Project No. 13112.21, Task 1

RE: Safety-Kleen Corp. Medley, Florida Construction Permit Application

**RESPONSE TO FDER COMMENTS DATED SEPTEMBER 27, 1990 FOR
SAFETY-KLEEN CONSTRUCTION PERMIT APPLICATION
FILE NUMBER HC 13-175466
SAFETY-KLEEN CORP.
MEDLEY, FLORIDA**

STANDARD STORM DRAINAGE DETAIL
EXFILTRATION TRENCH

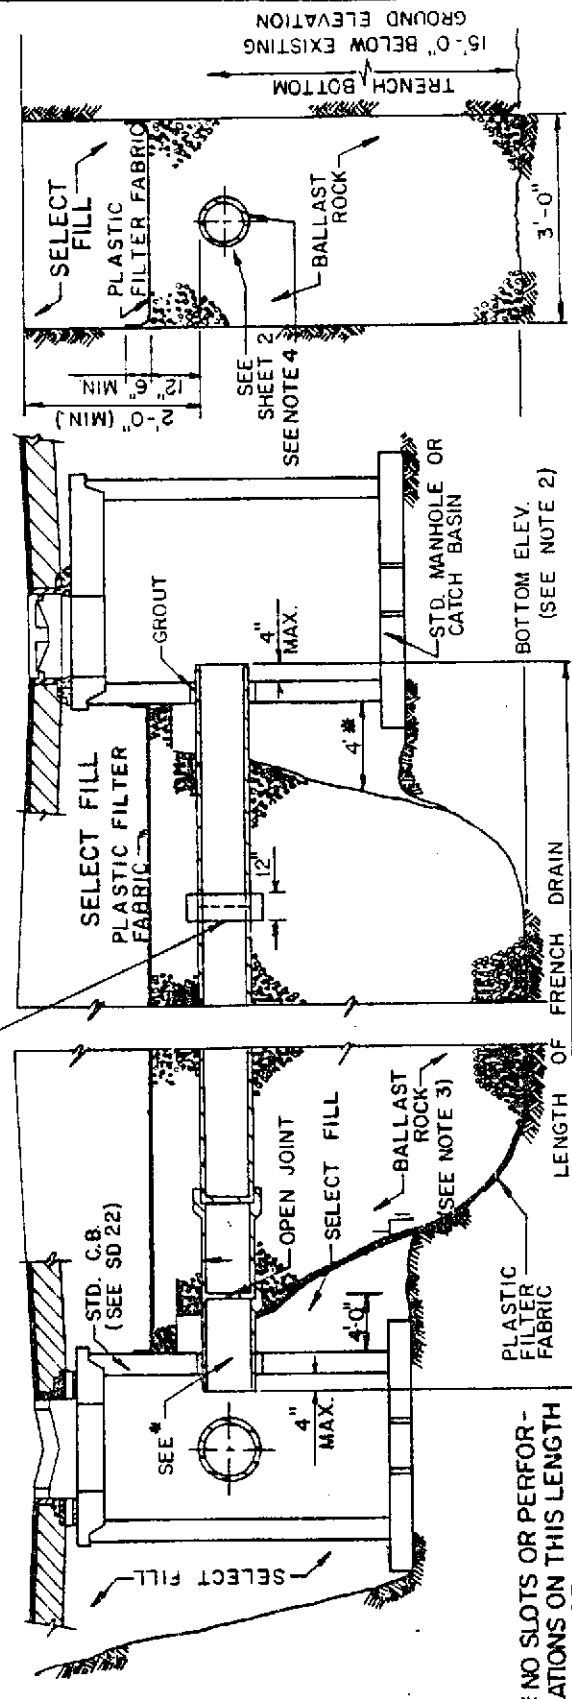
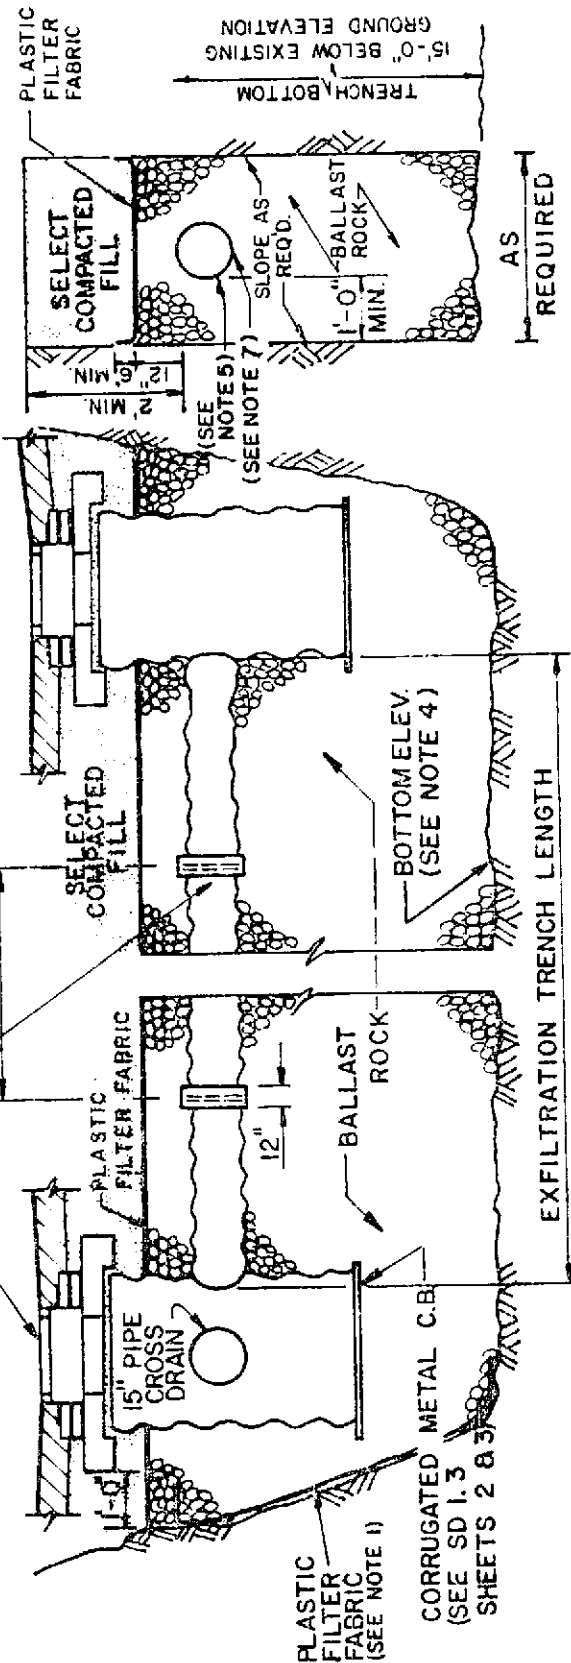
1. Provide a site-specific surface water management plan certified by the design engineer.

A site-specific surface water management plan is provided. This is a new Exhibit numbered Exhibit I.B.6-1 and should be placed immediately following Exhibit I.B.5-1.

TITLE
24" DIAMETER STAINLESS STEEL SUMP LINER FABRICATION

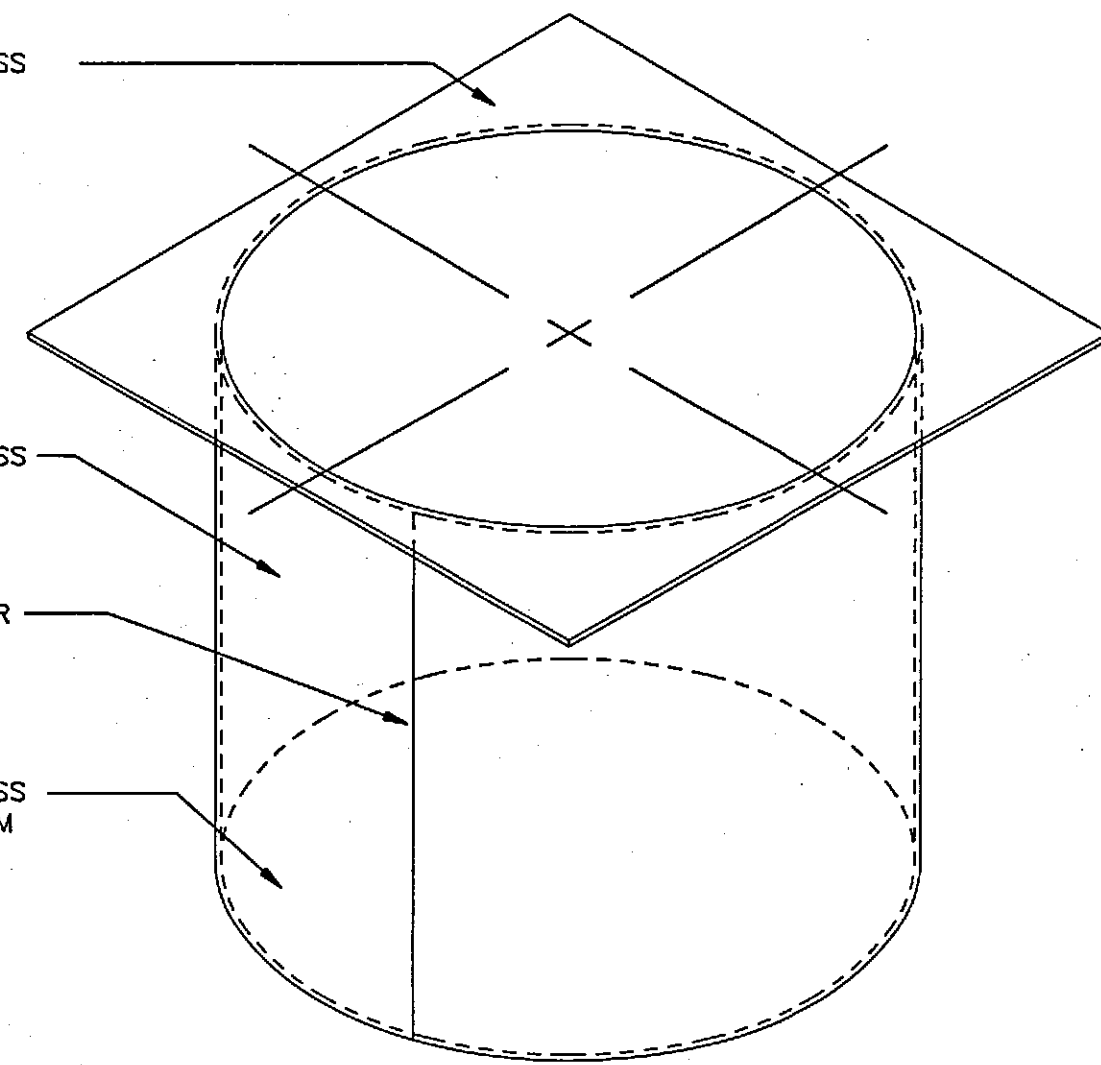
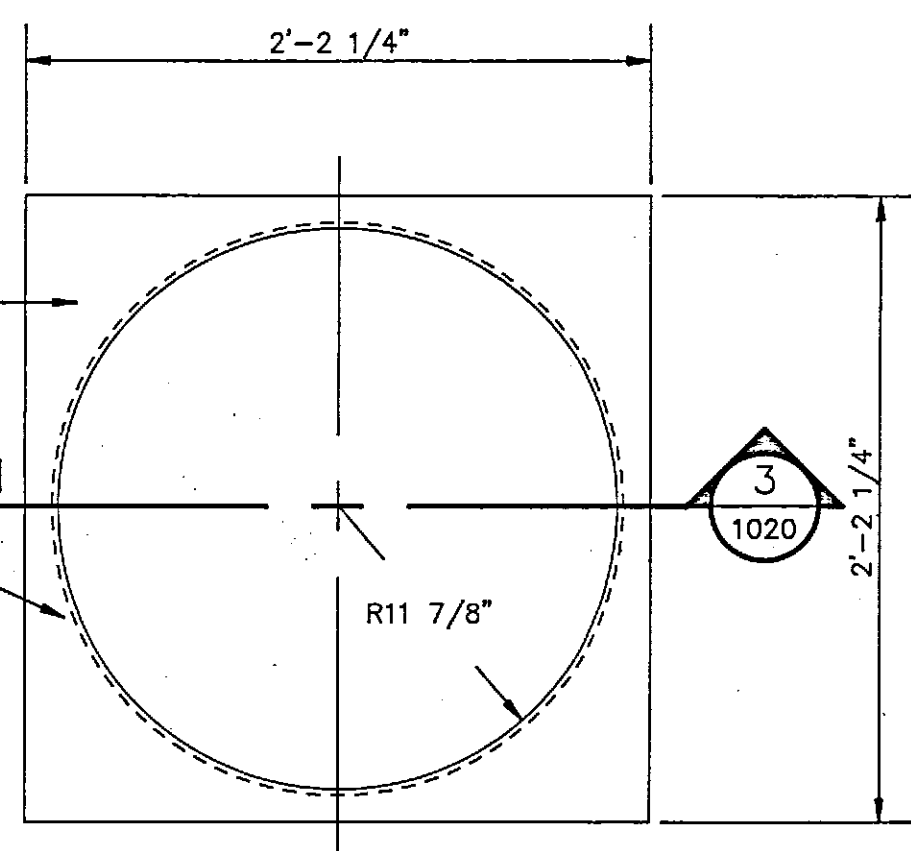
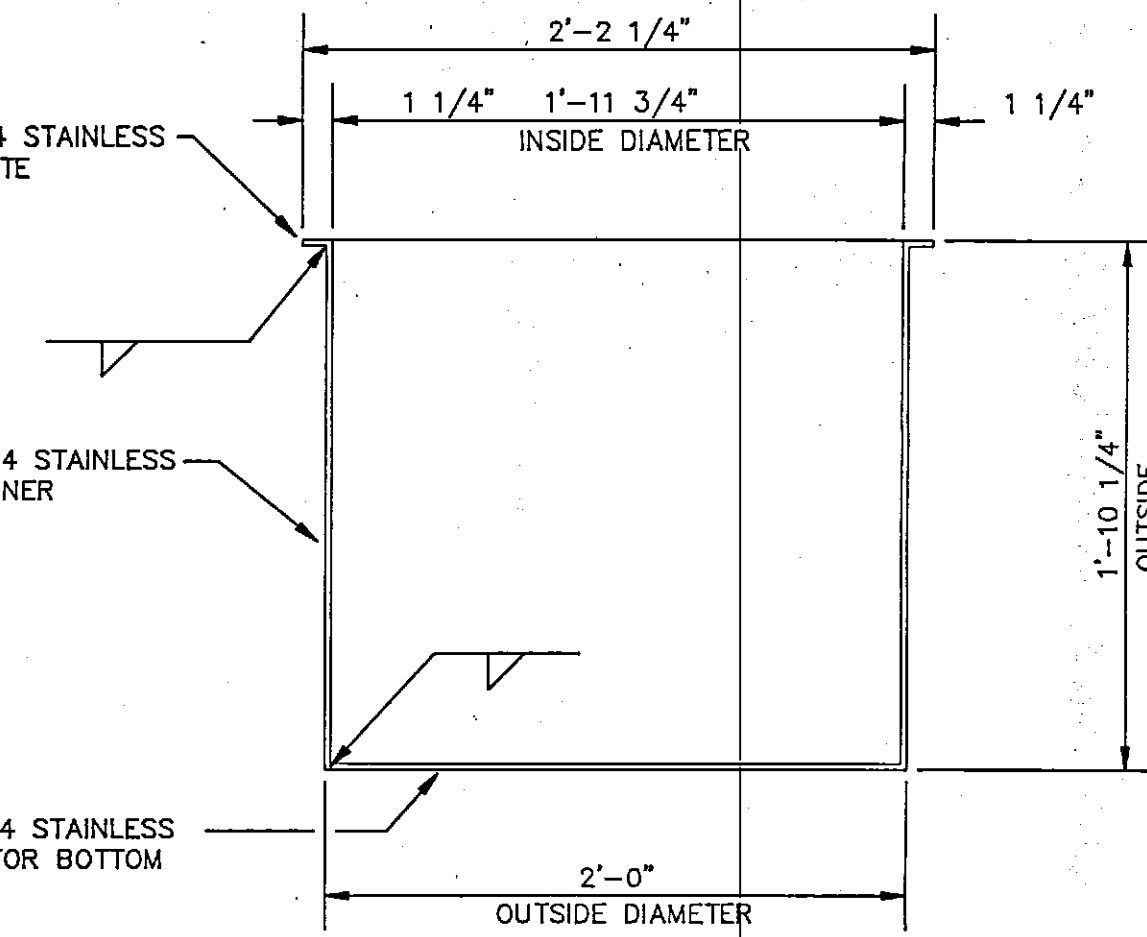
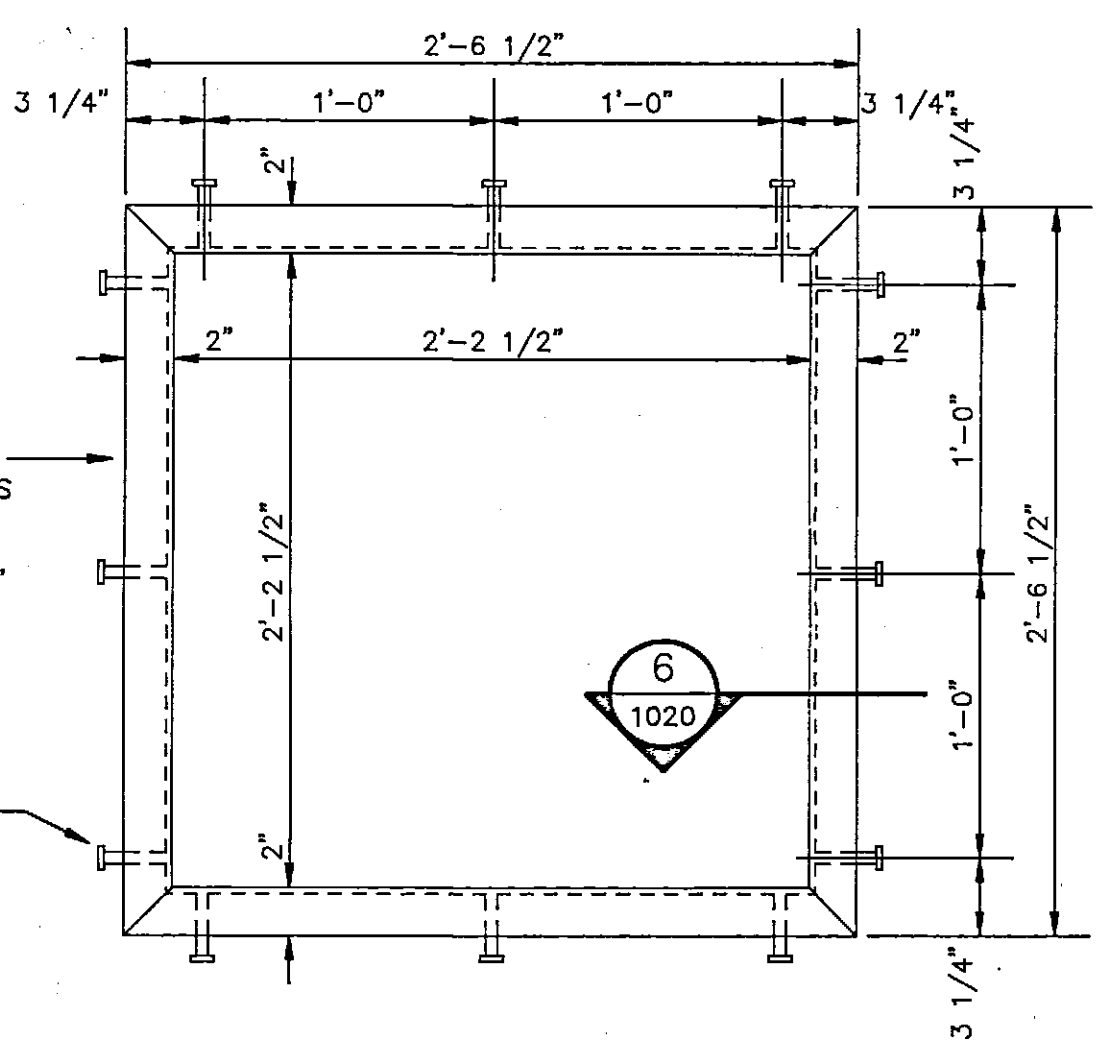
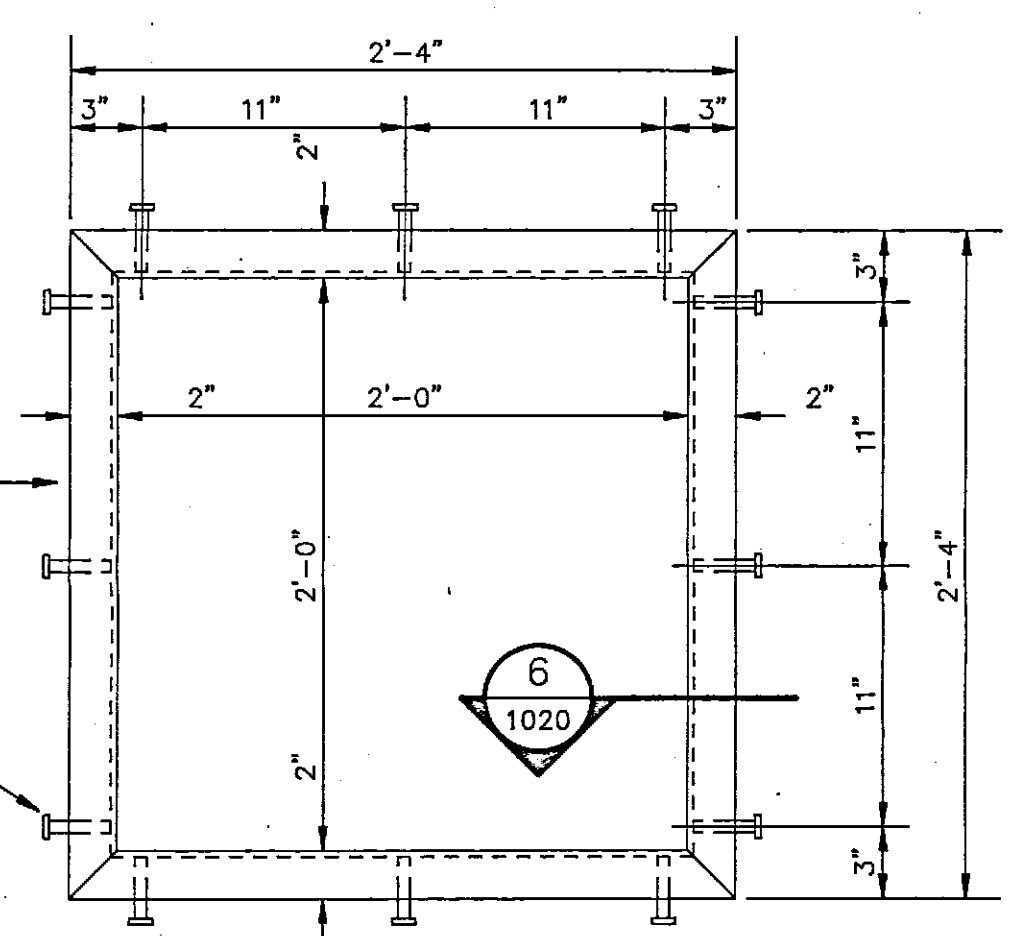
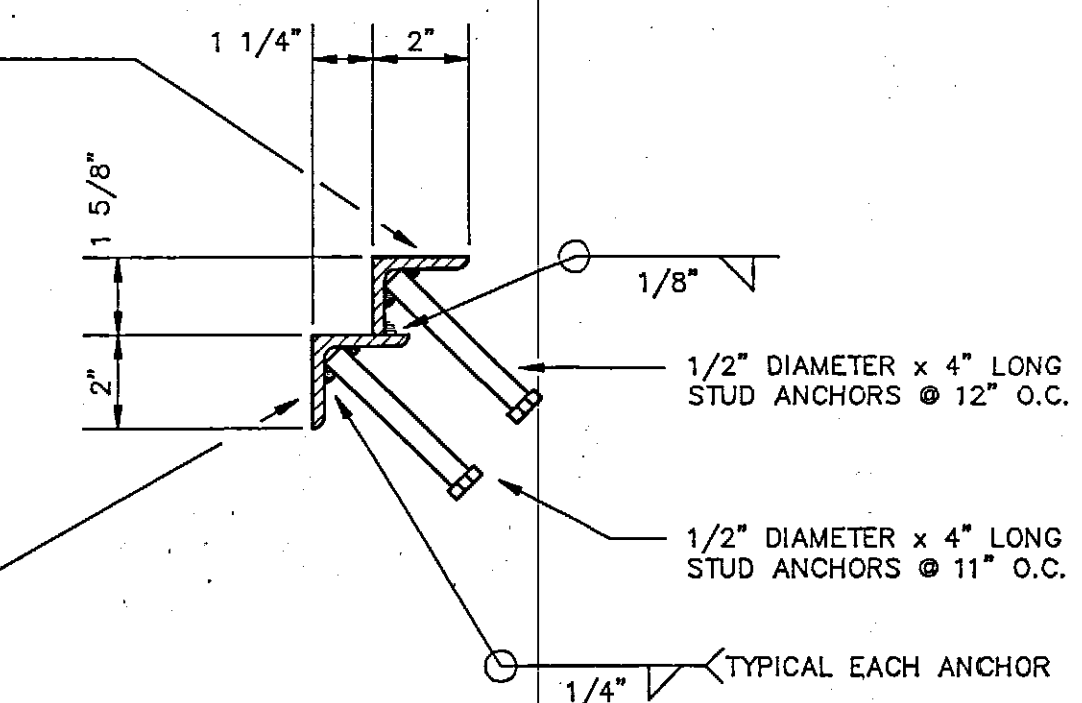
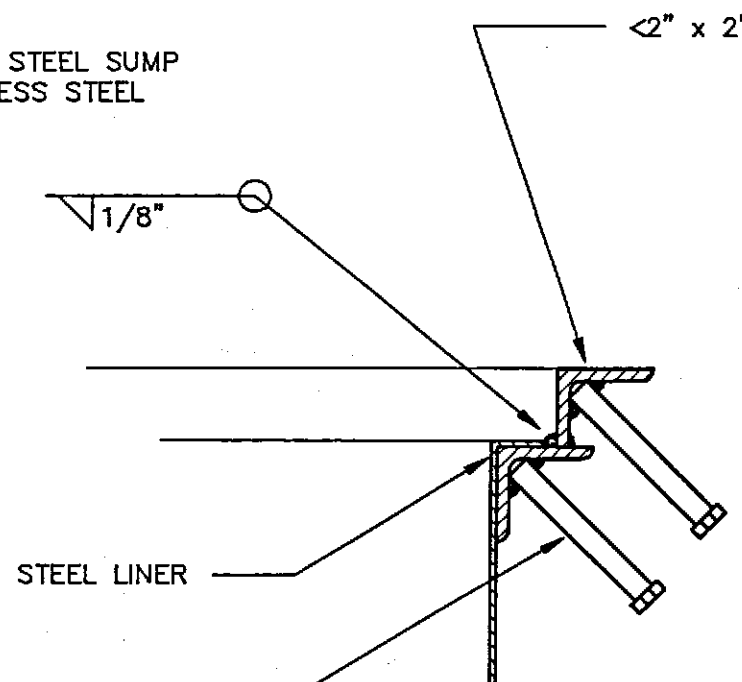
3. Provide manufacturer's specifications which support that the sump liner (SIC Part No. 5280) is compatible with all solvents with which it may come in contact. (Exhibit I.E. 3-10).

Safety-Kleen Drawing STD-1020-00 (24" Diameter Stainless Steel Sump Liner Fabrication) (Exhibit I.E.3-12) provides for a stainless steel sump liner to be

used at the Medley facility. Stainless steel is compatible with the primary constituents of Safety-Kleen's waste streams.
